Before the Board of Inquiry  
Waterview Connection Project

Rebuttal evidence of **Tim Fisher (Stormwater and Streamworks)** on behalf of the **NZ Transport Agency**

Dated: 2 February 2011

**ANNEXURE C: UPDATED DRAWINGS****Drawing 20.1.11-3-D-D-300-118 Rev C**

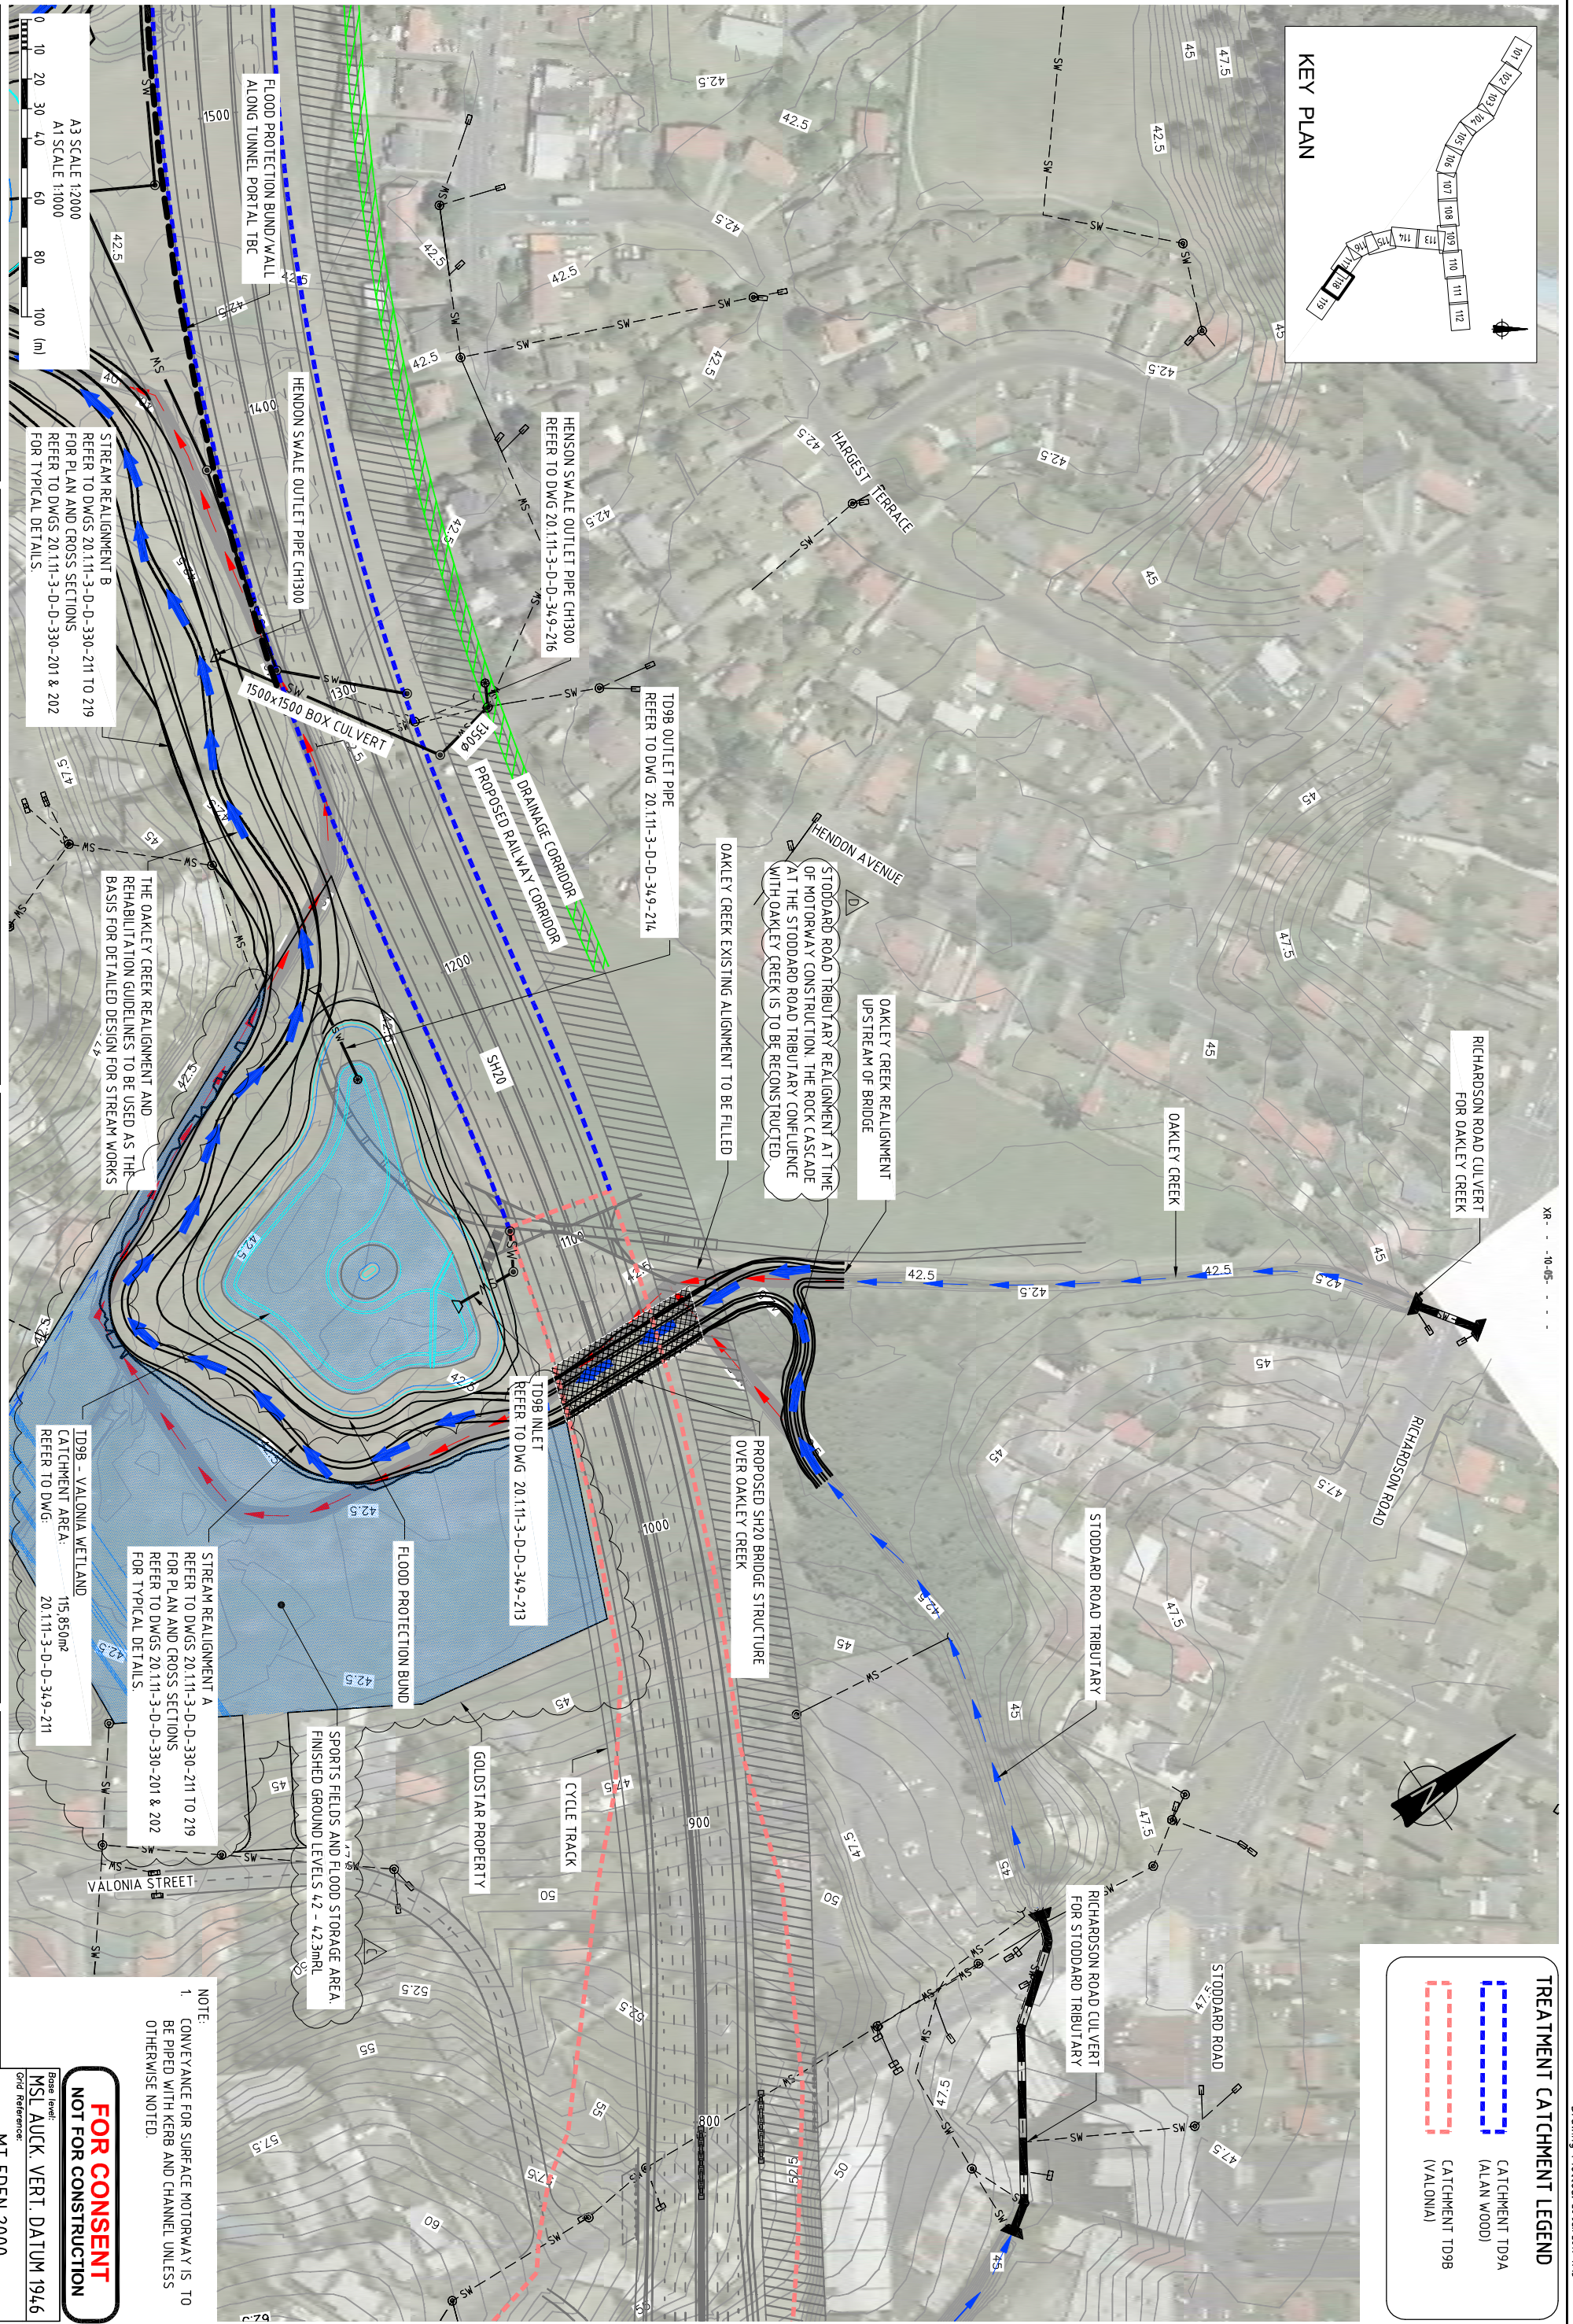
- 51 The requirement for the recreation of the cascade was discussed with the freshwater ecology experts during caucusing. It was agreed<sup>69</sup> to specify this requirement with an additional sentence in STW.20(c) (refer **Annexure B**). This change is also noted on drawing 20.1.11-3-D-D-300-118 Rev D,<sup>70</sup> which is attached to this evidence as **Annexure C**.

Updated note requiring cascade in Stoddard Road Tributary at confluence and clarifying timing of realignment
